Worthing Road, Southwater (Phase 4)

Rebuttal to Tree Officer Comments

Document Ref: BERK21219_Technote_(16.04.25)

Figure 1: Indicative specification of how adequate ground protection and tree protection fencing can be incorporated into development scaffolding offset from plot footprint

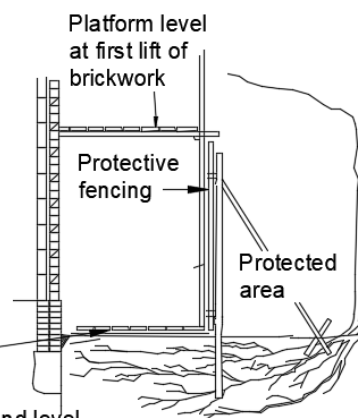
The relationship of proposed plot 133 is too close to the Oak tree (ref: T130) subject of Tree Preservation Order no 0227.

The build out will foreseeably require development operations within its minimum recommended RPA, which despite being greenfield development has not been designed to enable robust protective fencing around the entire minimum recommendation in this respect.

A 1.5m offset of the robust protection fencing specification shown on the Tree Protection Plan from the footprint of the dwelling has been allowed for scaffold erection with Ground Protection specified to the east of the plot's footprint where fencing offset results in exposed soft ground within the RPA. Adequate ground protection and fencing can be incorporated into the scaffolding for the plot as per the figure included at the end of this report.

Figure 3: Screenshot taken from Google Streetview (March2024) showing tree T130 to the rear of existing property having previously been reduced

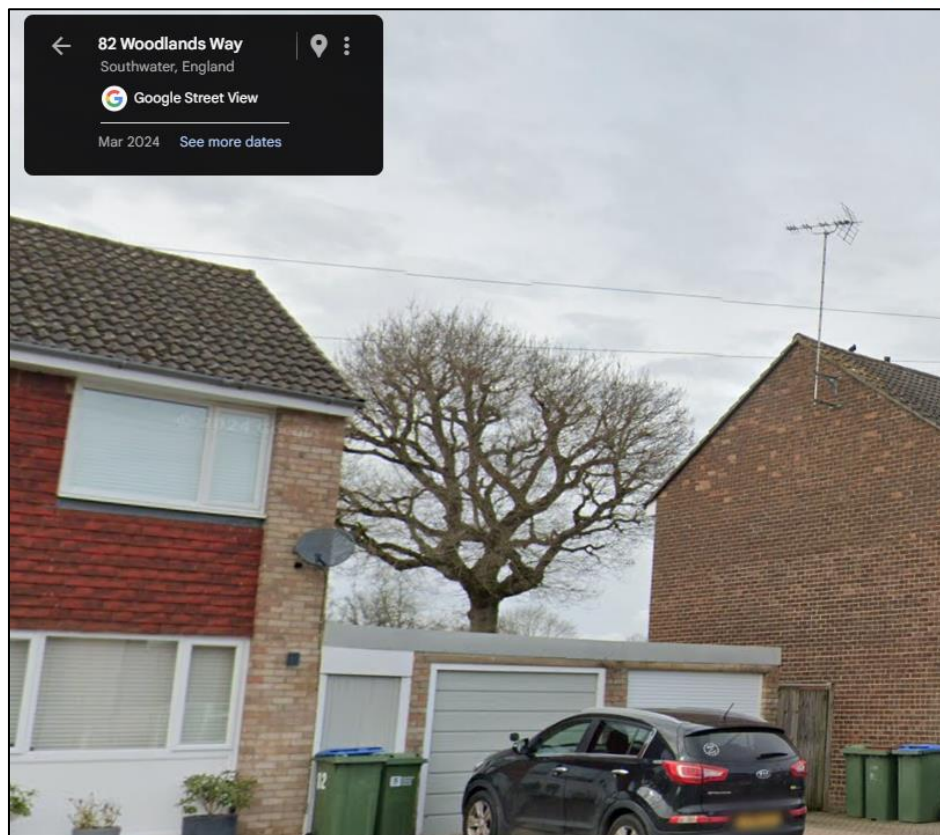
This type of build out requirement is symptomatic of a design of new habitable build and associated amenity space that is too close to the tree and will foreseeably place additional future pressure on the tree for lopping/felling in the future.

It is further observed using available street-view imagery that tree T130 has historically undergone a relatively significant whole canopy reduction – this shows a precedent of ‘acceptable’ pruning scope previously granted for the tree which could potential be re-implemented has been created, and it is also reasoned that the justification for this previously approved work was for purely aesthetical reasons given the current distance of the tree to the property within the boundary it is located, and therefore any future pruning that may potentially be required due to re-growth and ensuring a suitable relationship with an adjacent dwelling in the future would therefore, surely, be of a far more justifiable stance.
